APPLICATION FOR AMENDMENT TO PERMIT

To the INSPECTOR OF BUILDINGS, PORTLAND, MAINE 03 April 1998 216-A-006

Amend sign plans to taller sign

BUILDING PERMIT REPORT

Sign For E.I.
Roger L. Belar
Scale = 1" =

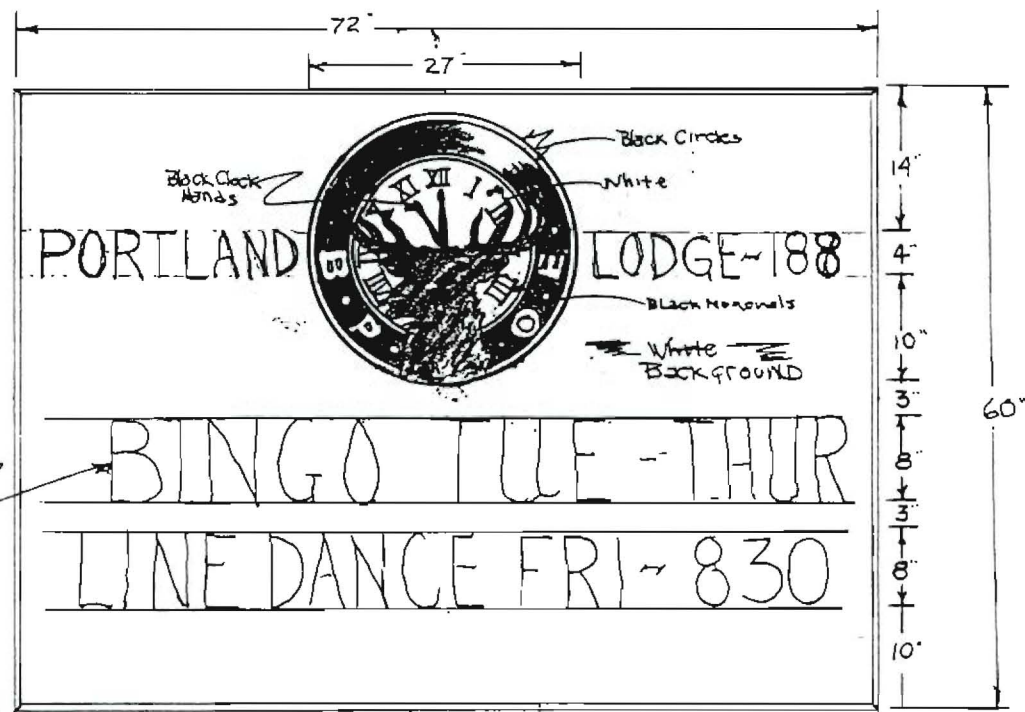
⑨ Other requirements of condition This Approval is only for a one year time period, at which time this sign shall be removed (anticipated relocation of the lodge prior to that time)

⑩ This exception shall not extend to successors
